PARTS & SERVICE NEWS

REF NO.	AT04809A
DATE	Jun. 21, 2004

SUBJECT: MODIFICATION TO REPLACE RETARDER EPC VALVE, TO ADD ABNORMAL PRESSURE PREVENTIVE VALVE AND TO CARRY OUT FLUSHING OF TRANSMISSION + BRAKE CIRCUITS ON HD465/605-7

PURPOSE: To introduce modification procedures to replace the retarder EPC valve, to add the abnormal pressure preventive valve and to carry out flushing of the transmission + brake circuits on HD465-7 and HD605-7 dump trucks

Fig. 1

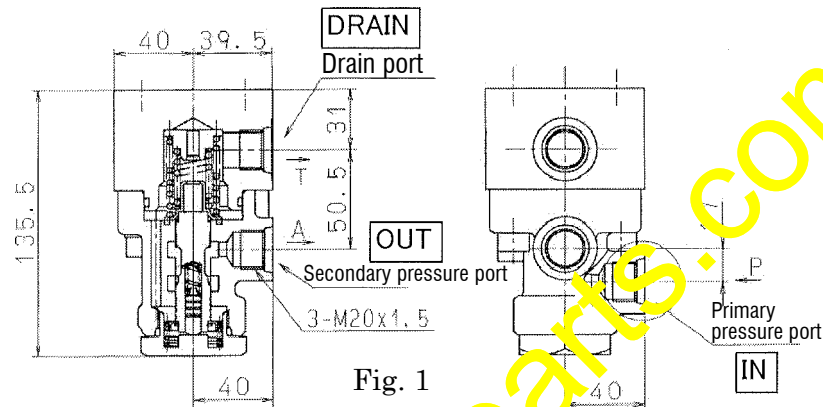
- For the purpose of keeping the brake circuit from abnormal high pressure even when malfunctioning occurs with the retarder EPC valve and when the pressure reducing function is lost, a valve to limit the primary pressure is to be installed in an upstream section of the EPC valve.

Fig. 4

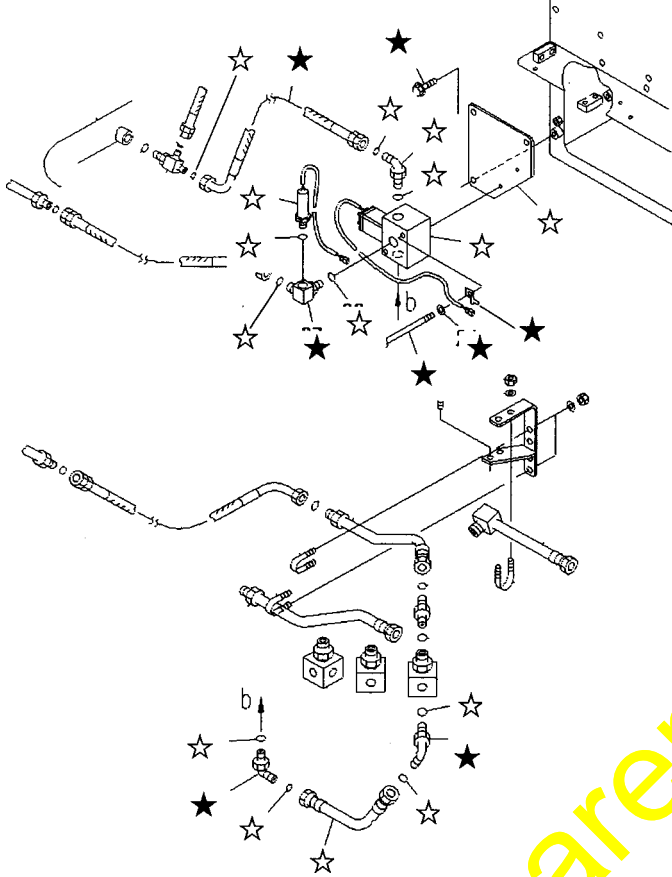
- 2) Remove the parts marked ☆ and ★ in the figure shown below. (Refer to Fig. 4 and Fig. 5.)

Fig. 6

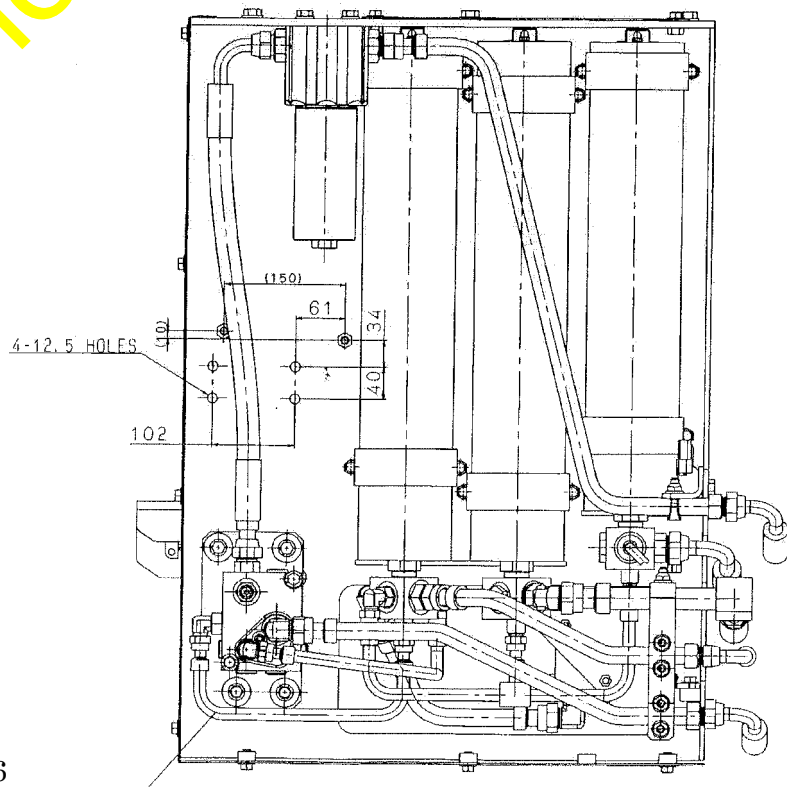
- 3) Rework the bracket onto which the accumulator is installed. (Refer to Fig. 6.)
(Drill at 4 places)

Fig. 7

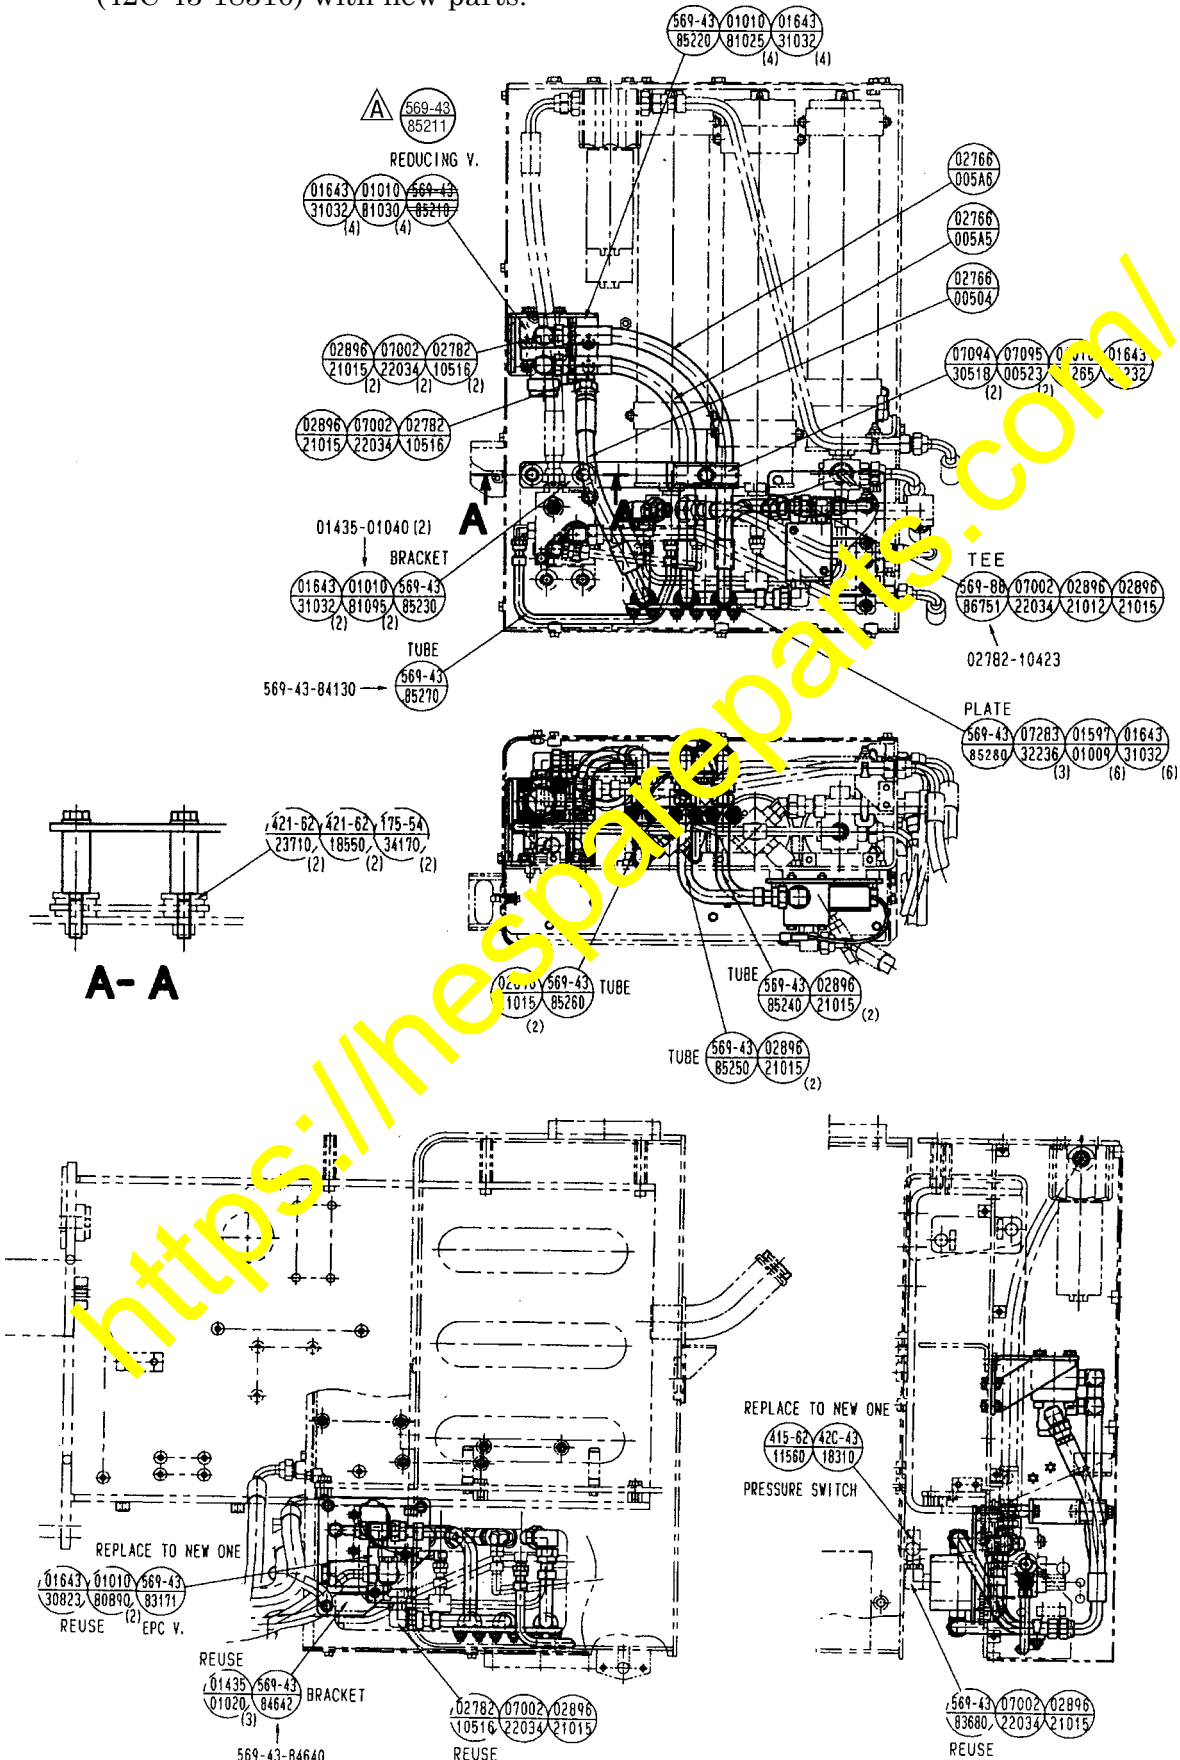
- 4) Referring to the drawing shown below, install the relief valve and the pipings, etc. (Refer to Fig. 7)
 At this time, replace the EPC valve (569-43-83171) and the oil pressure switch (42C-43-18310) with new parts.

Fig. 8

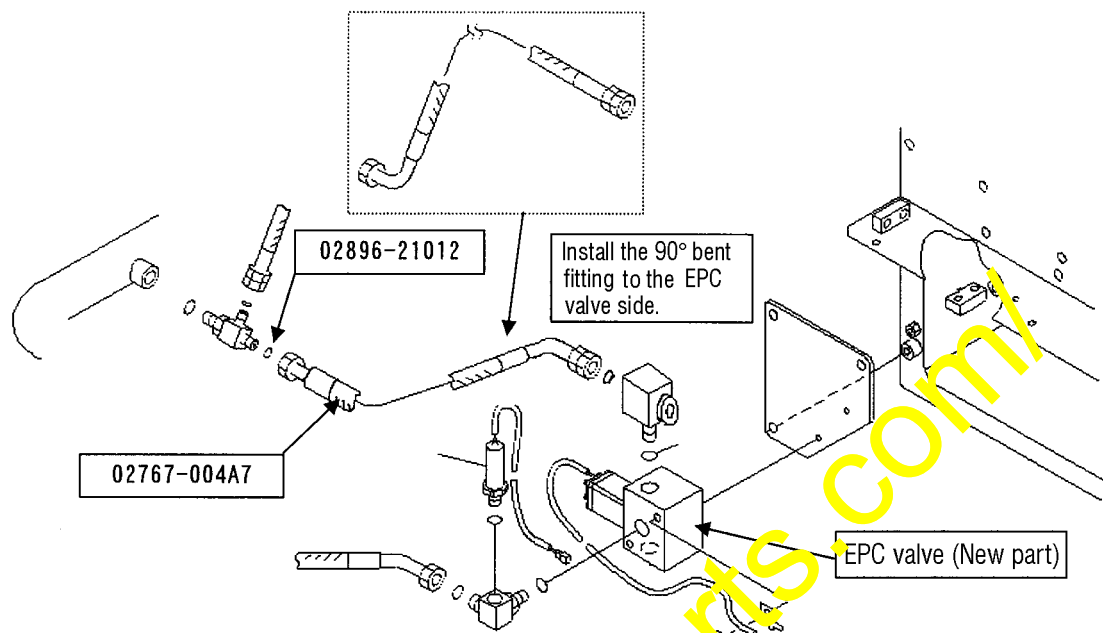
- 5) Install the drain hose (02766-004A7) for the EPC valve in opposite direction to the direction before starting this modification work. (Refer to Fig. 8.)

Fig. 12

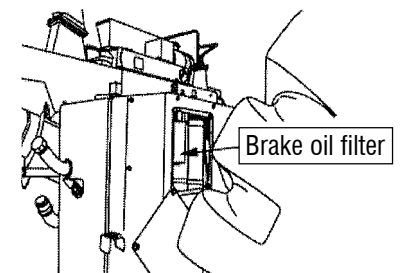
At the same time, replace the brake oil filter element with the new element.

- Brake oil filter element: 569-43-83920
(New element with improved filtration performance)

- * Regarding the brake oil filter, a new filter with improved filtration performance is introduced in the Service News. Install this new filter at the time of making periodical change after this.
